Final Drainage Report
for
Rolling Hills Ranch North Filing 1
at
Meridian Ranch

April 2024

SF-2411 — Revised

PCD Project No. SF-XXXX

RUNOFF REDUCTION
 CATCHMENT AREA A
 ROLLING HILLS RANCH NORTH PUD

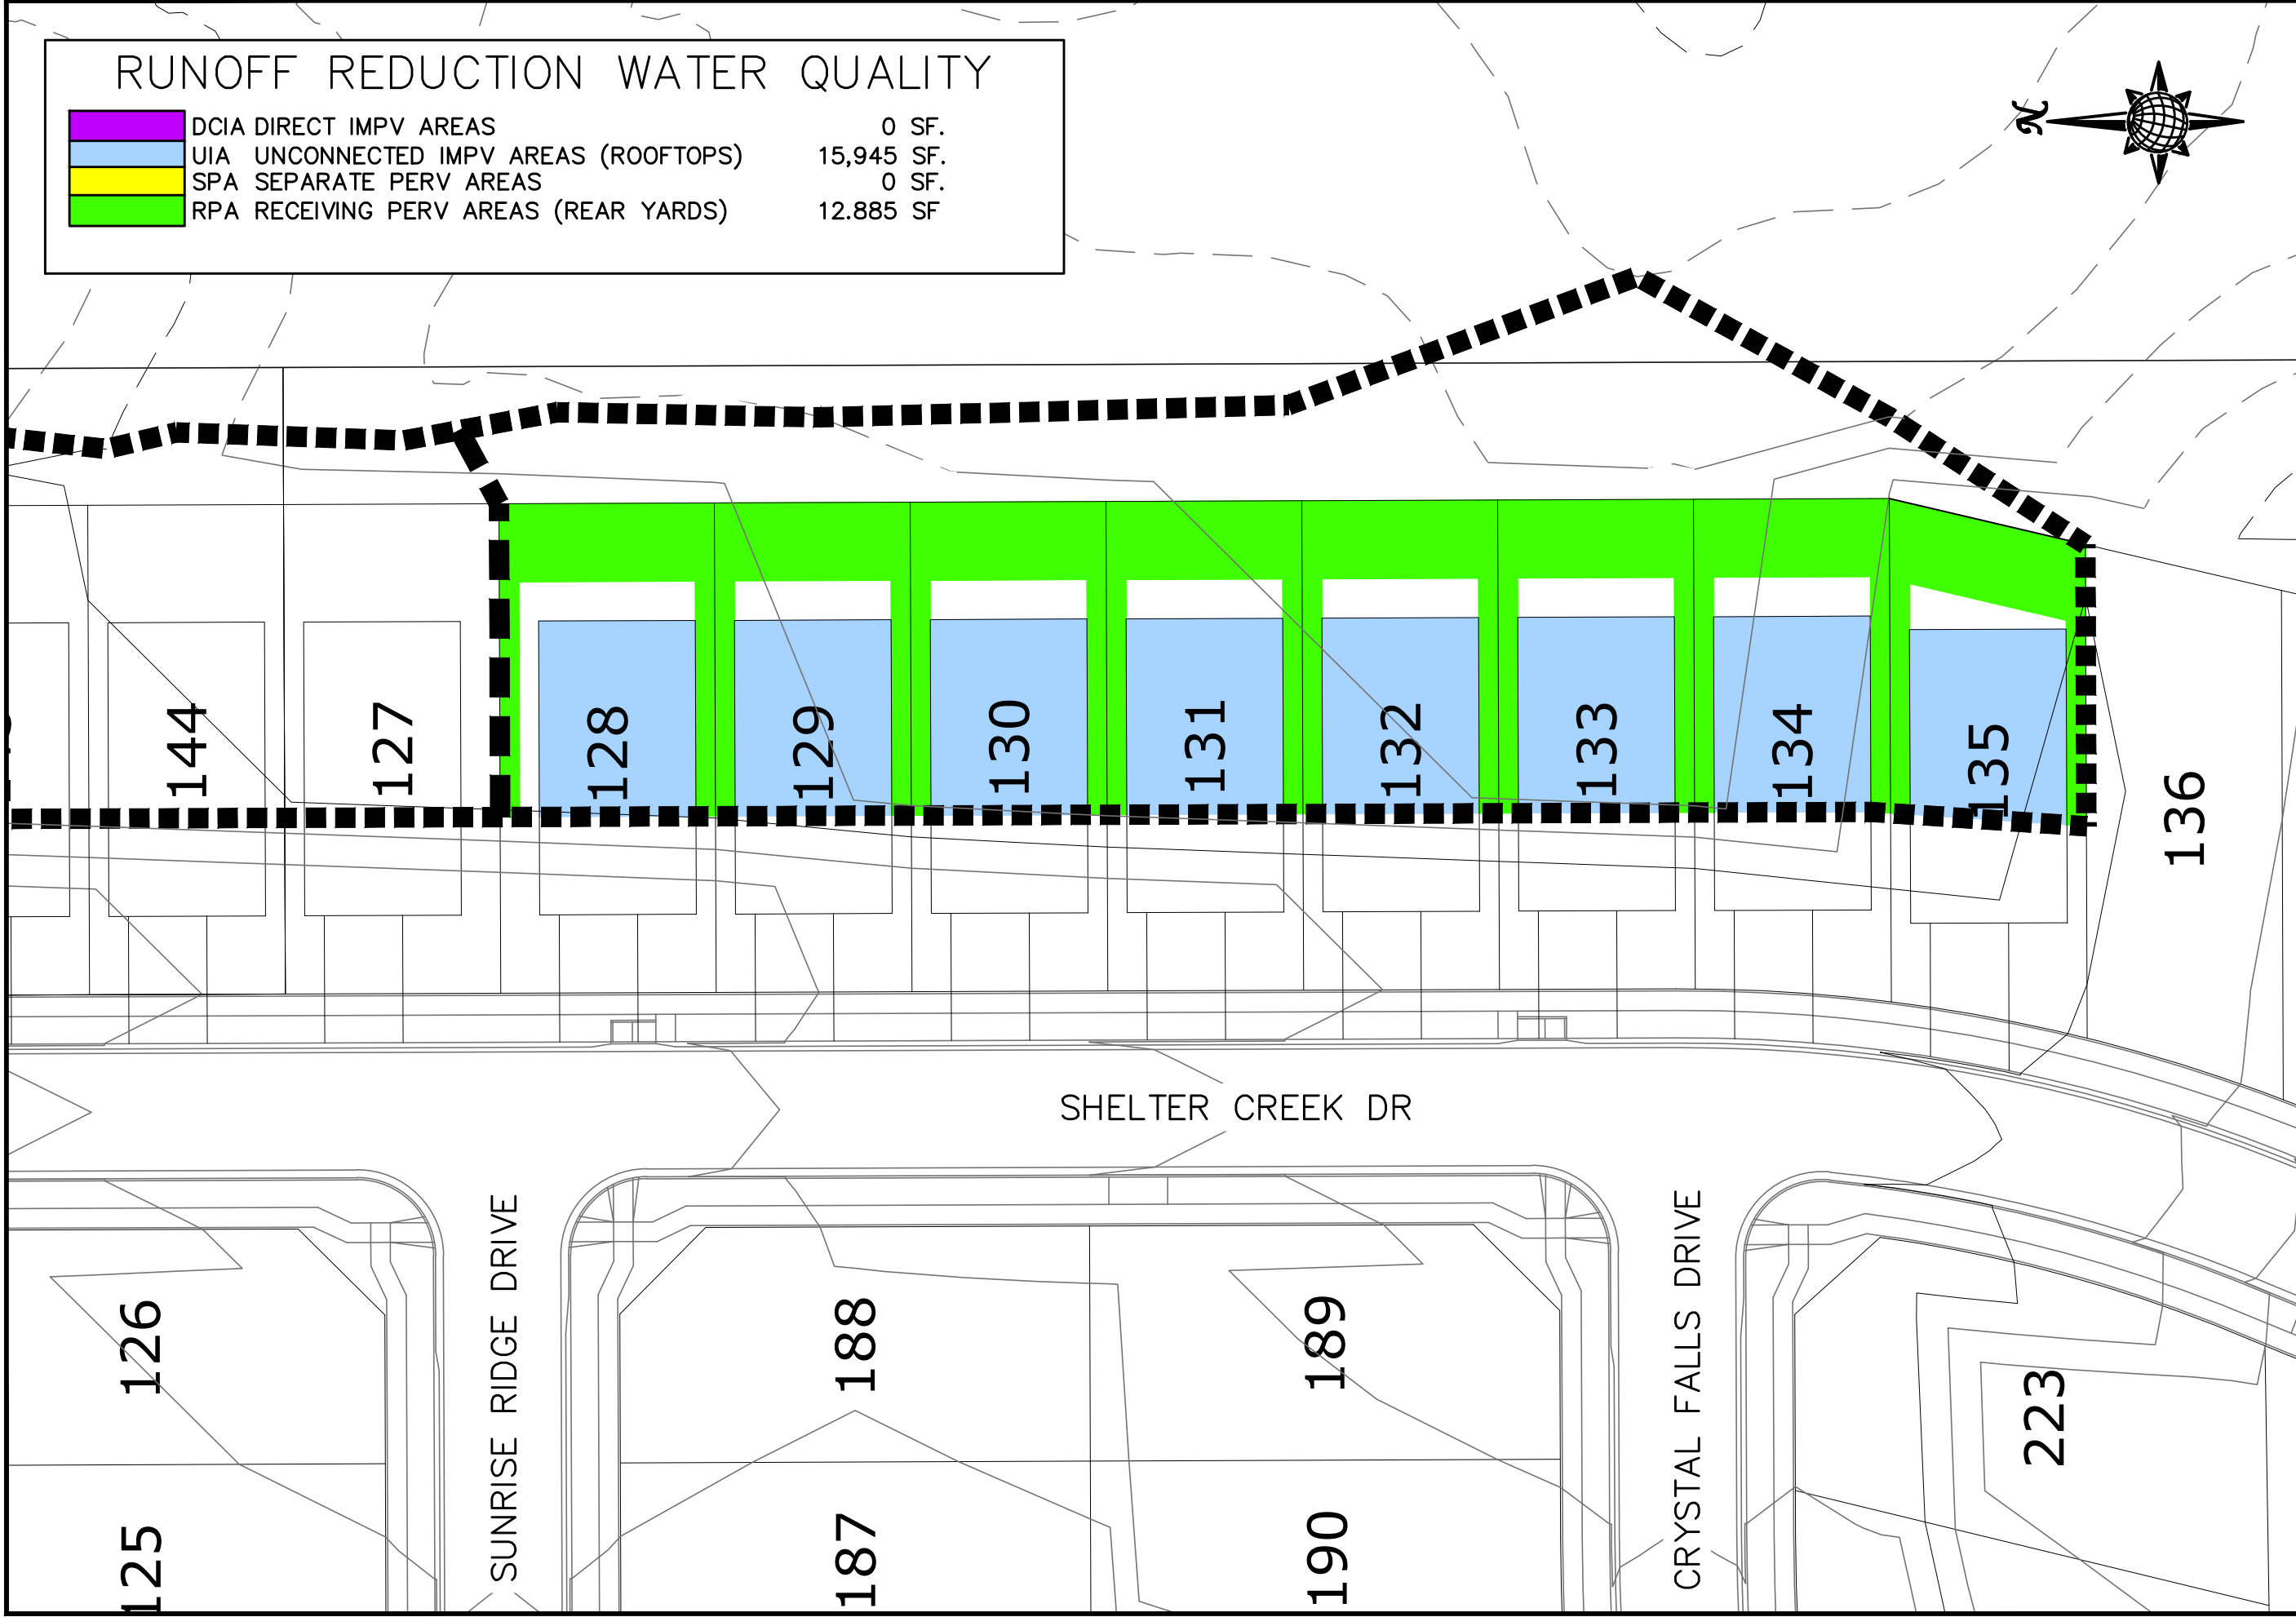
Where is this applicable? Previously it was stated it would only be for Filing 2, if so please remove.

FIGURE 8

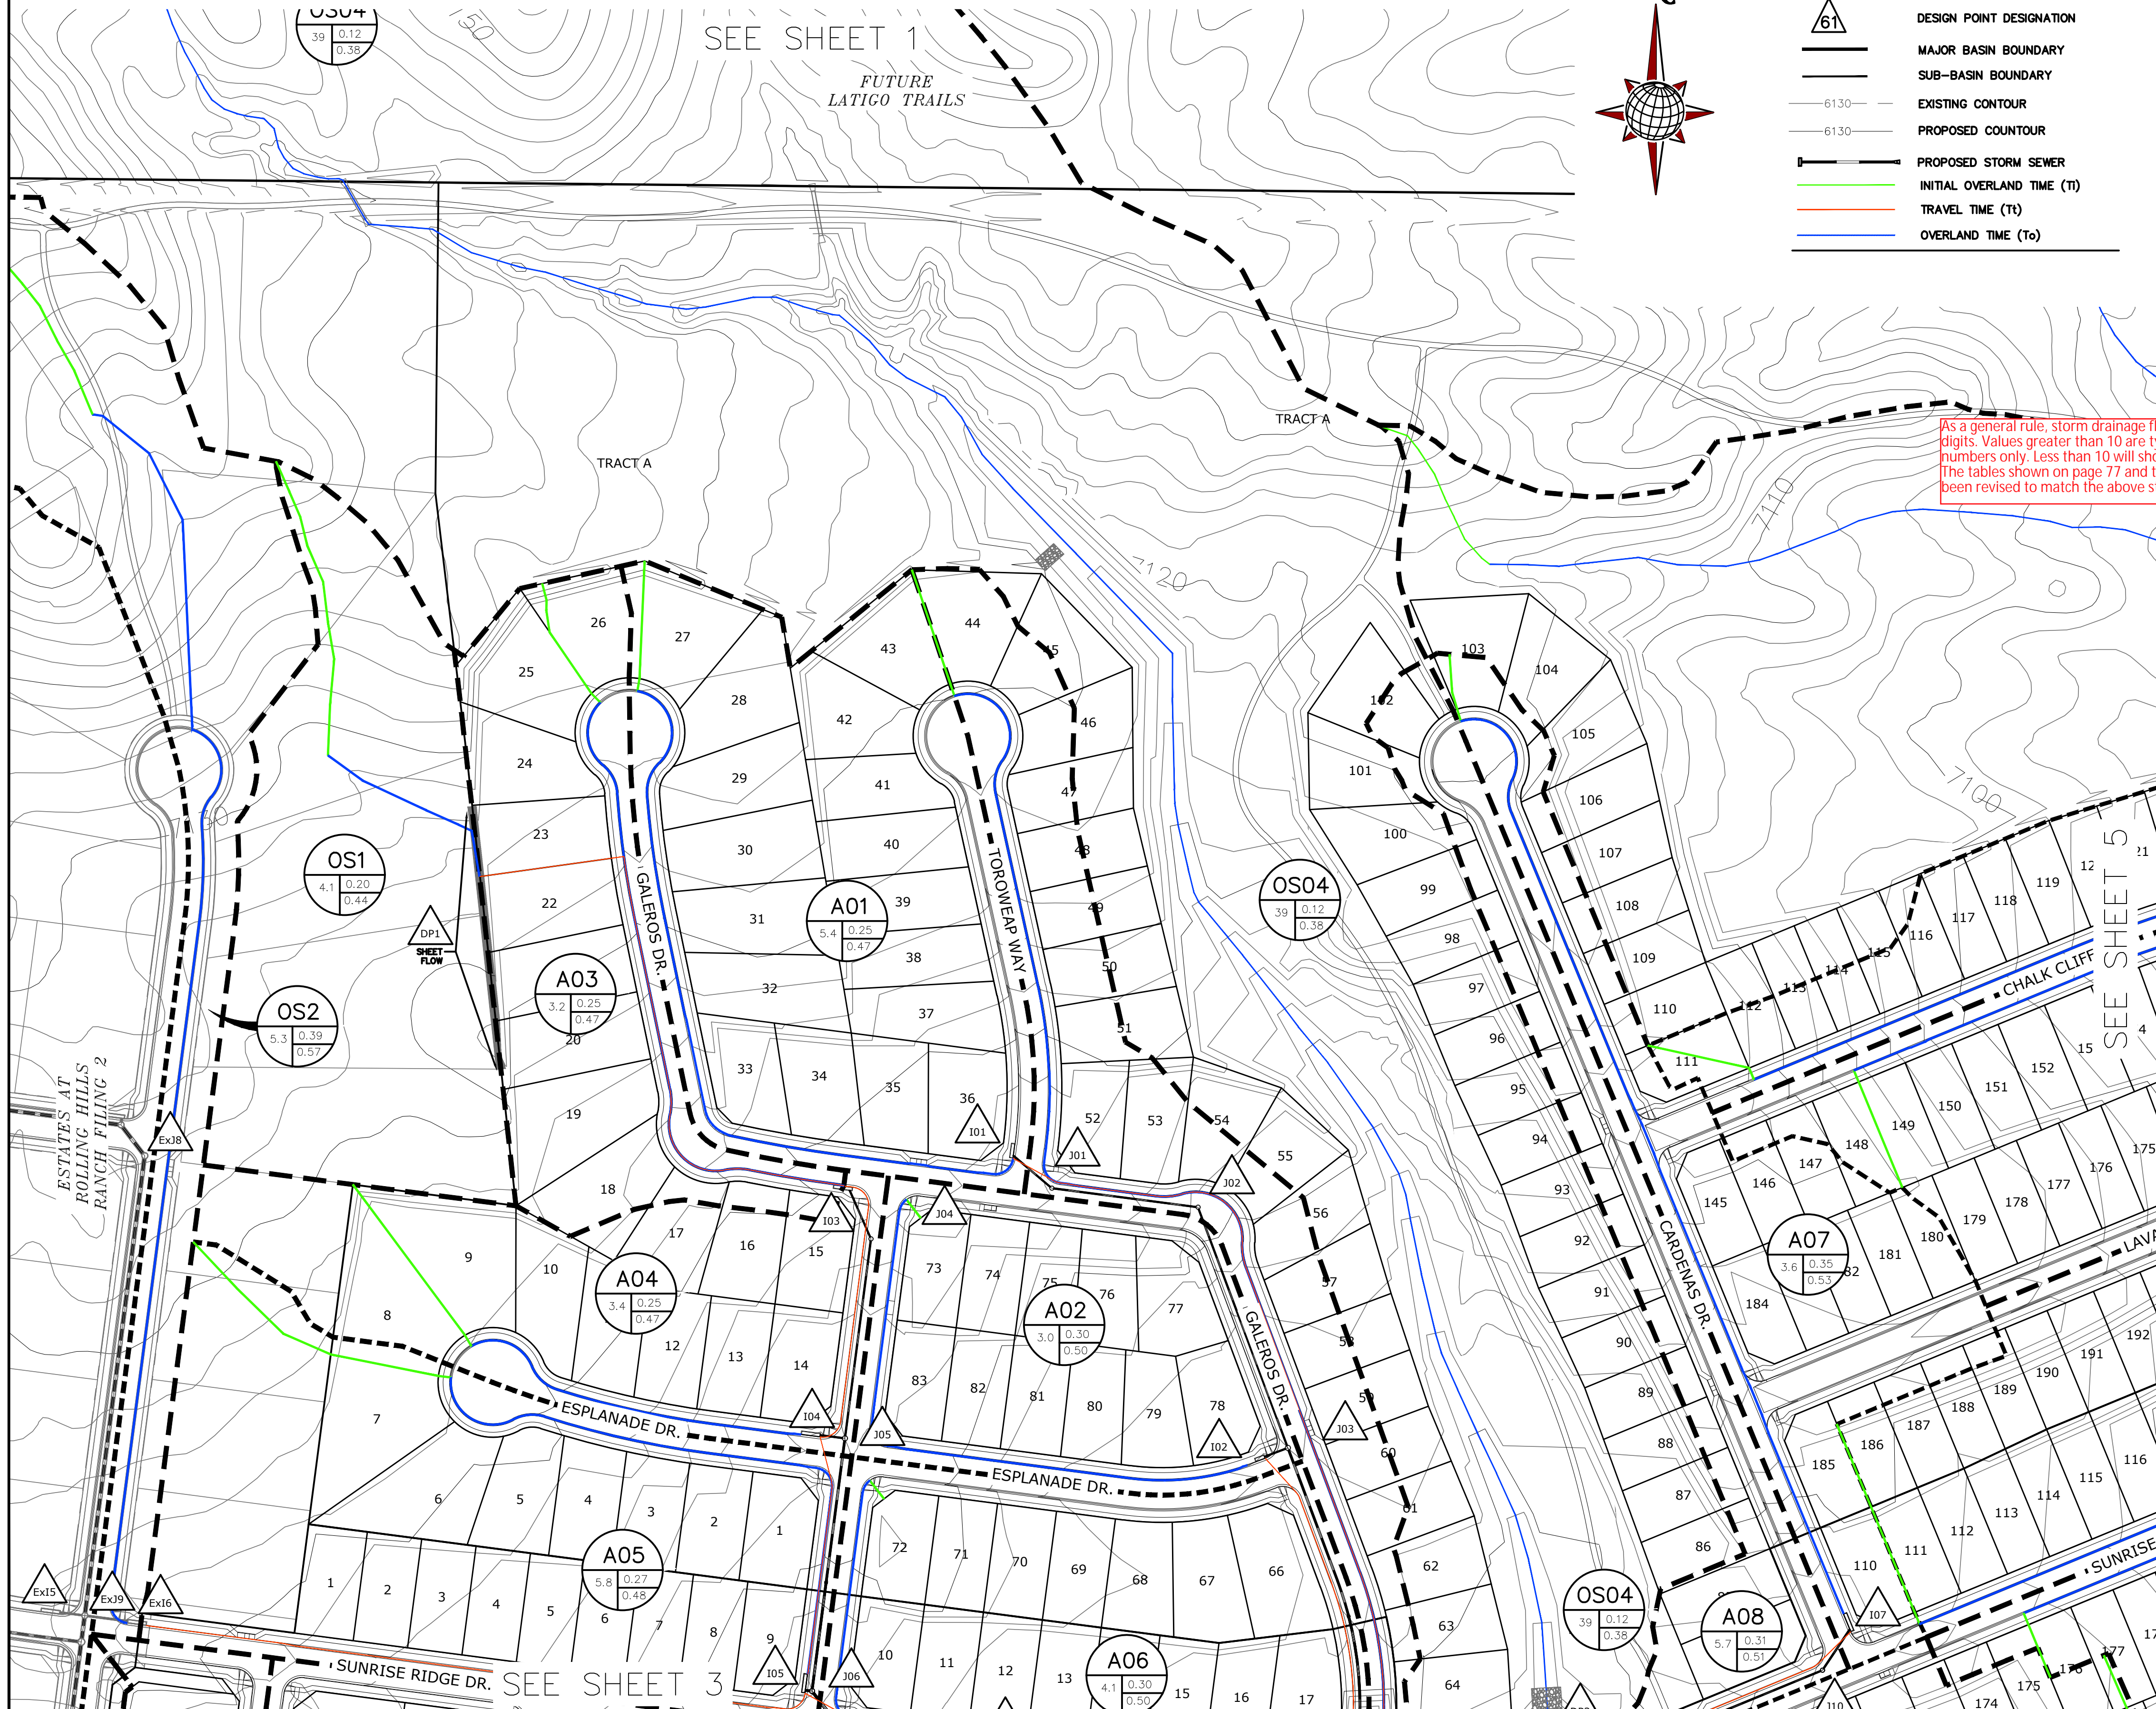
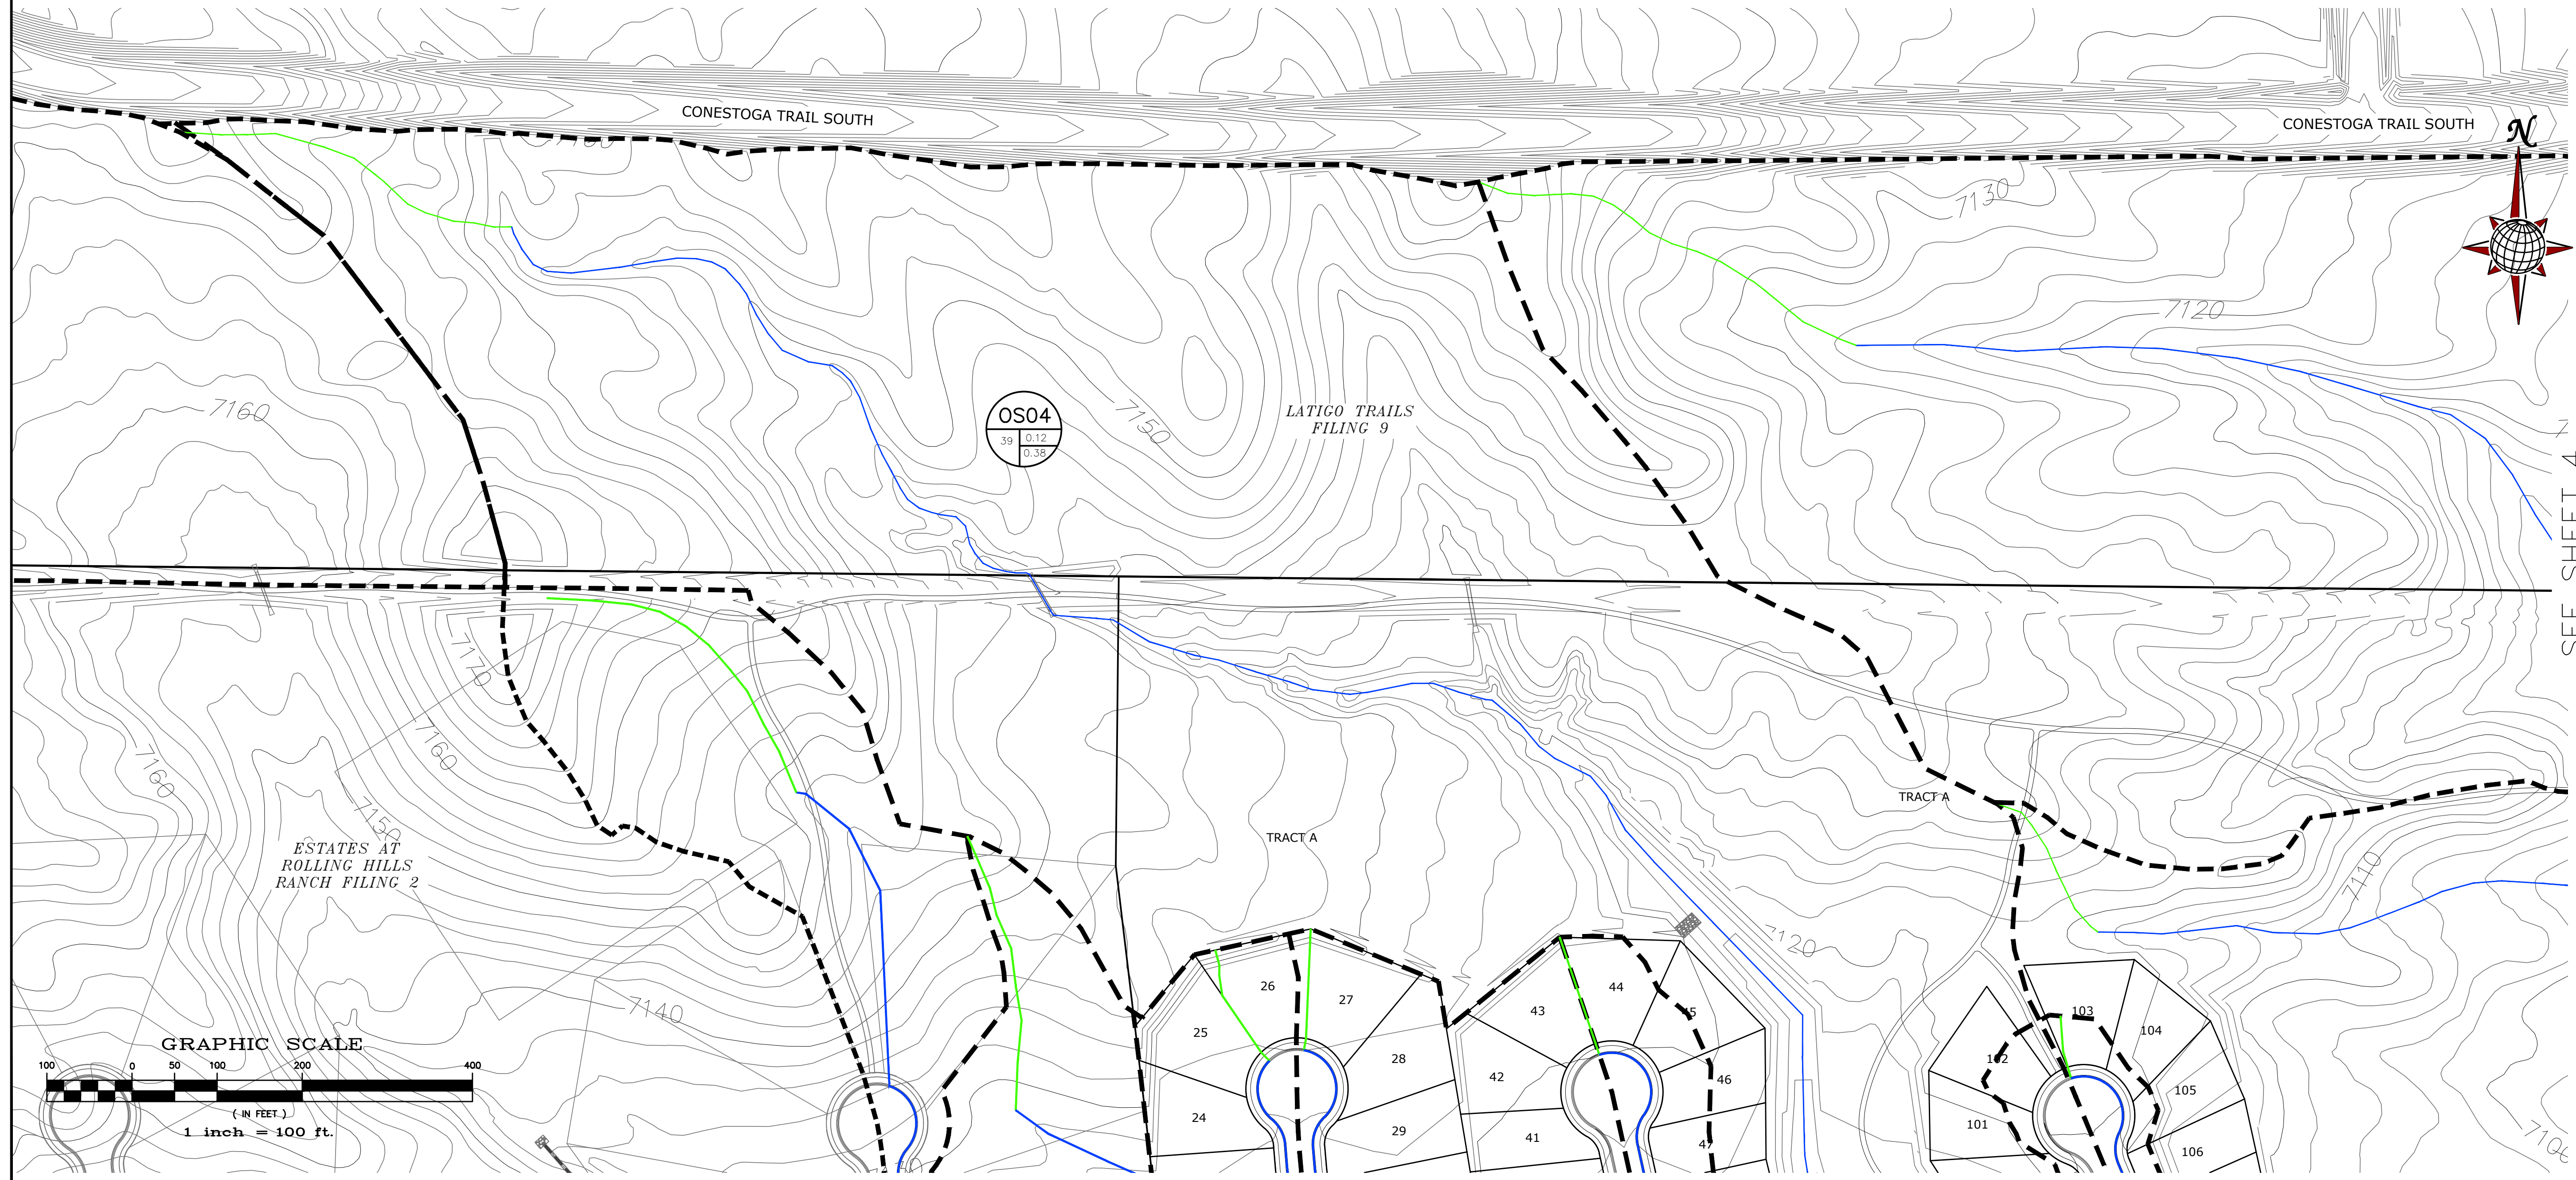
Figure 8 is not a water quality map and is not located in Appendix G, please include water quality map.

Revised and added

Please revise to reflect the decimal value as well. Table in Fig 8 includes the decimal values.

As a general rule, storm drainage flows shown to 2 significant digits. Values greater than 10 are typically shown as whole numbers only. Less than 10 will show values to the tenth of a CFS. The tables shown on page 77 and the maps in the appendix have been revised to match the above stated standards.
